CERTIFICATE OF APPROPRIATENESS

Property: 7710 Glenbrae Street, Lot 3, Block 65, Glenbrook Valley Section 7 R/P Subdivision. The property includes a historic 1,952 square foot residence situated on a 8,250 square foot (75' x 110") corner lot.

Proposal: Project Type – Alteration

Replace the existing vertical wood gable siding, and shake shingle siding over the attached garage, with horizontal lap cementitious siding. Replace the existing pair of garage doors with a single garage door. Replace all existing aluminum framed windows with vinyl windows of matching style and divided lite configuration.

EAST SIDE ELEVATION
EXISTING

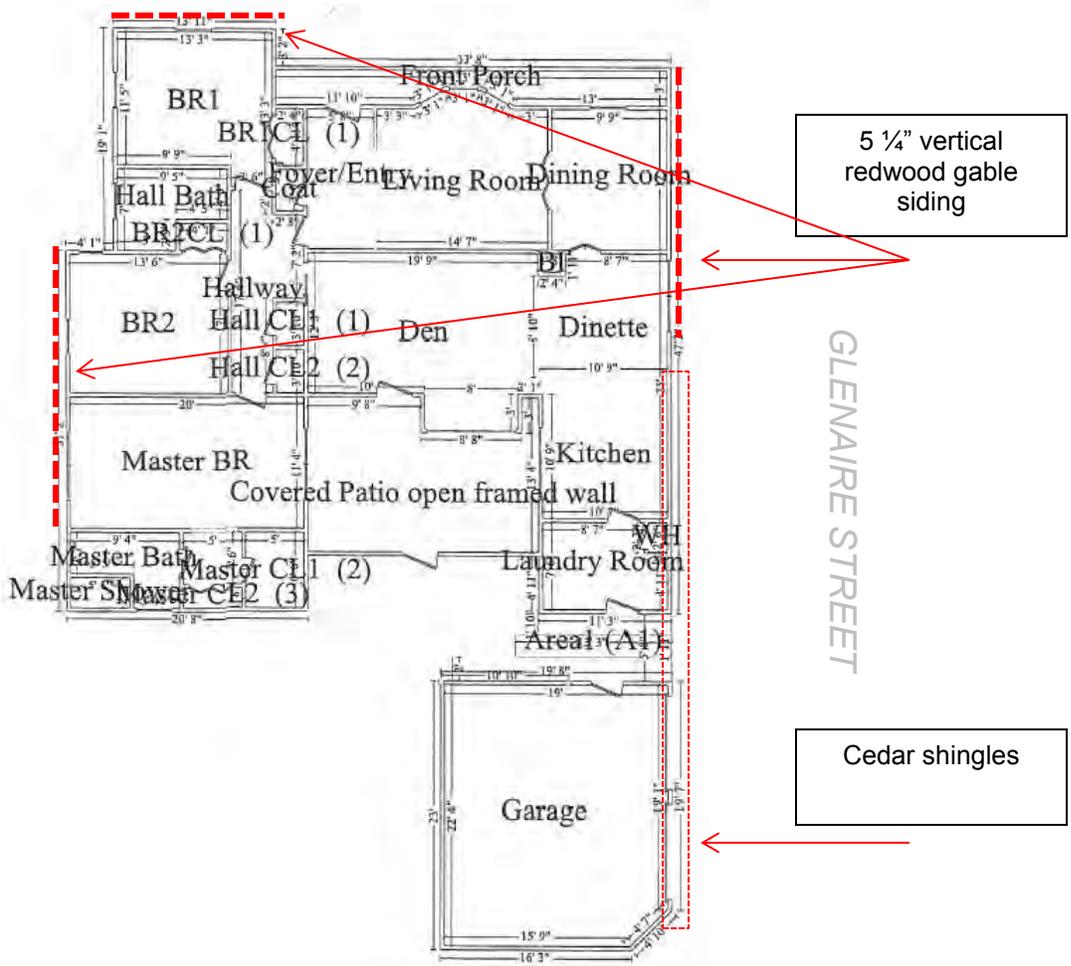
- The applicant retain the existing double door configuration on the attached garage
- The existing damaged 1" thick by 5 1/4" wide wood vertical siding is replaced with matching material
- The existing damaged cedar shingle siding is replaced with matching material
- The existing damaged 1" thick by 4" wide V-groove soffit is replaced with matching material

- (4) The proposed activity must preserve the distinguishing qualities or character of the building, structure, object or site and its environment;
The existing pair of garage doors and wood cladding are distinguishing characteristics of this structure and other Contributing structures found within the Glenbrook Valley Historic District. Replacing them with newer materials fails to retain these characteristics.

- (5) The proposed activity must maintain or replicate distinctive stylistic exterior features or examples of skilled craftsmanship that characterize the building, structure, object or site;
The existing cedar shingle siding, vertical redwood siding, and wood V-groove soffit material are distinctive stylistic features found on this structure and other Contributing Traditional Ranch style homes found within Glenbrook Valley. Although these existing materials are damaged enough to warrant replacement, it is inappropriate to replace them with contemporary cementitious cladding.

FLOOR PLAN
EXTERIOR CLADDING
GLENBRAE STREET

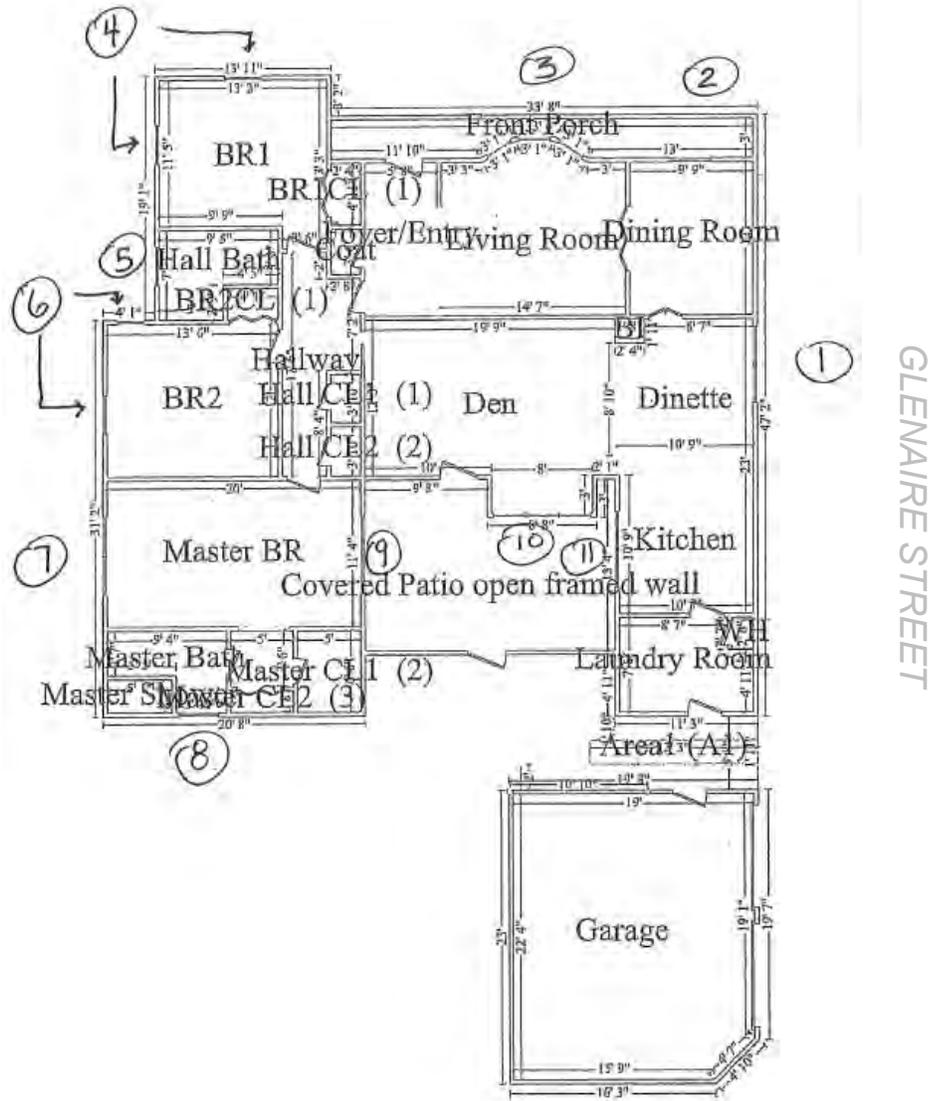
- (9) The proposed design for any exterior alterations or addition must not destroy significant historical, architectural or cultural material and must be compatible with the size, scale, material and character of the property and the area in which it is located;
The proposed horizontal cementitious siding and soffit panels are materials that are not compatible with the existing structure's character. The existing wood shingle and vertical

siding features a unique texture and profile that would not be replicated by the more contemporary cementitious replacement material.
